BEFORE THE PUBLIC UTILITY COMMISSION OF OREGON

2019 Integrated Resource Plan

Docket LC 70

**SIERRA CLUB'S COMMENTS ON PACIFICORP STACKED COAL RETIREMENT
ANALYSES**

Figure 1. Historical Bridger Plant Delivered Coal Price from Bridger Mine

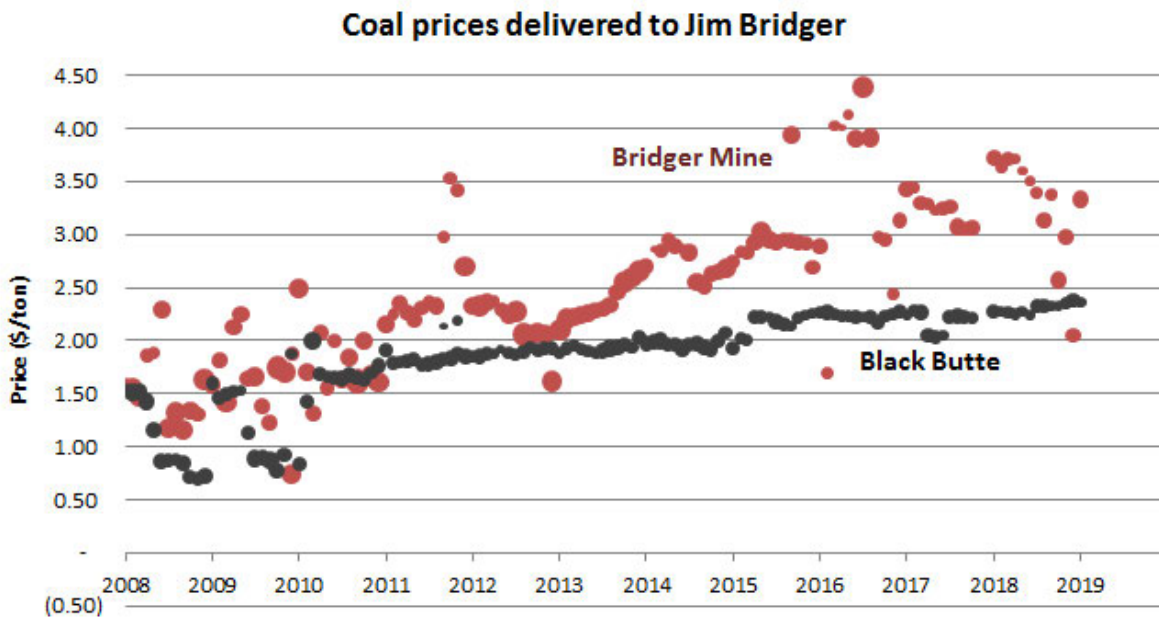
Jim Bridger receives coal from the nearby third-party owned Black Butte mine, but the majority of its coal is still supplied by the PacifiCorp majority-owned Bridger Mine. As shown in Figure 1, below, the delivered cost of coal from Bridger Mine has risen rapidly in recent years and generally maintained well above \$3/MMBtu,²⁴ making it the most expensive coal burned in the west. Even the coal from Black Butte has been rising at nearly 4% per year – a rate at which it would be expected to exceed \$3/MMBtu by 2024.

Thus, PacifiCorp’s Bridger coal price assumptions appear to depend on either the price of coal from the Bridger Mine and Black Butte decreasing substantially in the future or Bridger transitioning to receiving a greater percentage of its coal from alternative, lower-cost mines. PacifiCorp should provide greater clarity regarding the basis for its Bridger coal price assumptions.
